CITY OF ALBUQUERQUE

**RE: Legacy 2 Multifamily
7800 Headline Blvd NE
Conceptual Grading and Drainage Plan
Engineer's Stamp Date: 03/27/20
Hydrology File: D17D107**

Based upon the information provided in your submittal received 03/27/2020, the Conceptual Grading & Drainage Plan is approved for action by the DRB on Site Plan for Building Permit.

GP01
GRADING PLAN

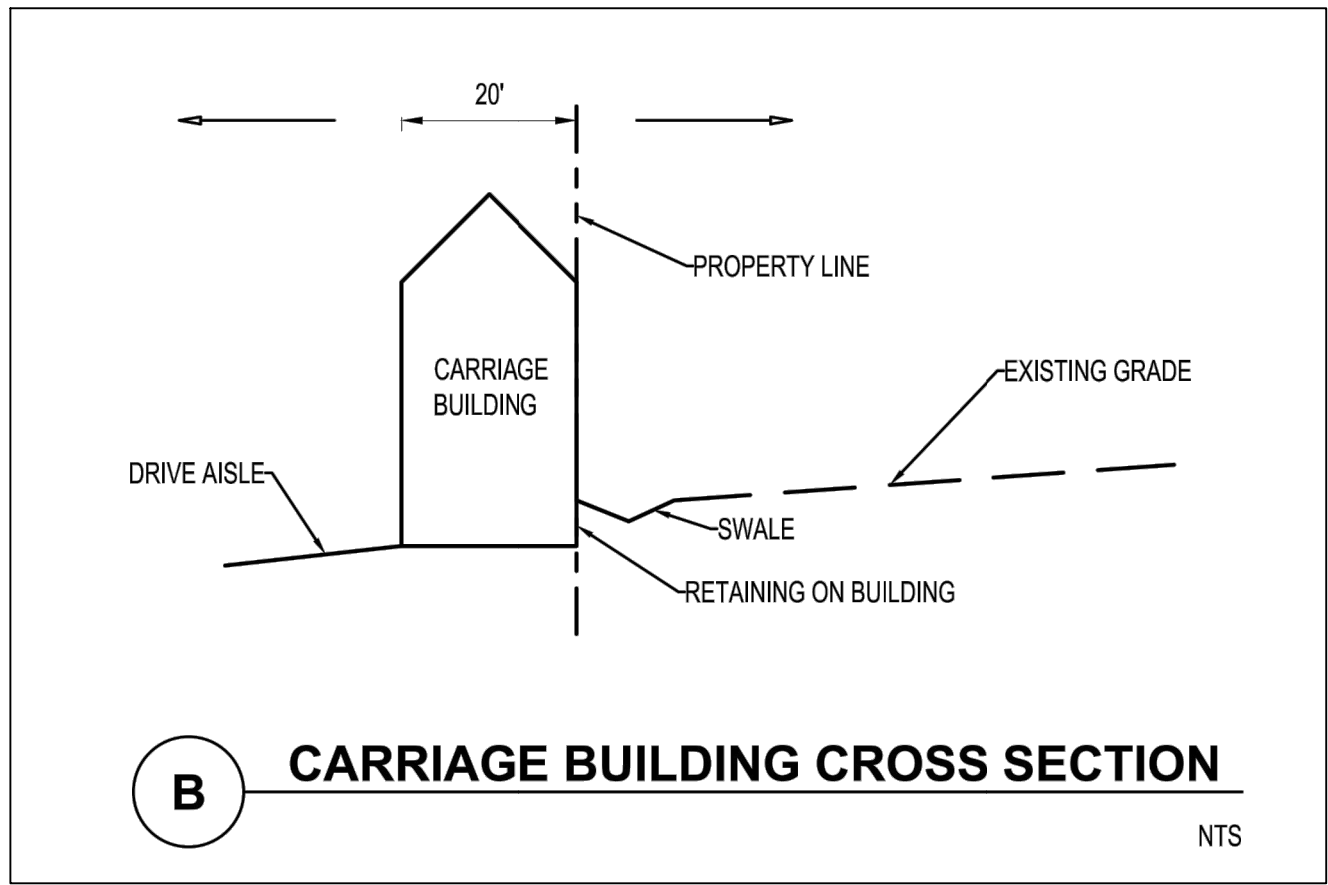
- In accordance with DPM Ch.22, section 5 part B, grading and wall construction near the property line may not endanger adjacent property or constrain its use. If the proposed retaining wall will create such an encroachment, written agreement from both landowners must be provided for such work. Written permission must include: signature of the property owner or owners representative, statement that undersigned is the owner or authorized representative, permission to construct the encroachment with a brief description of the encroachment.
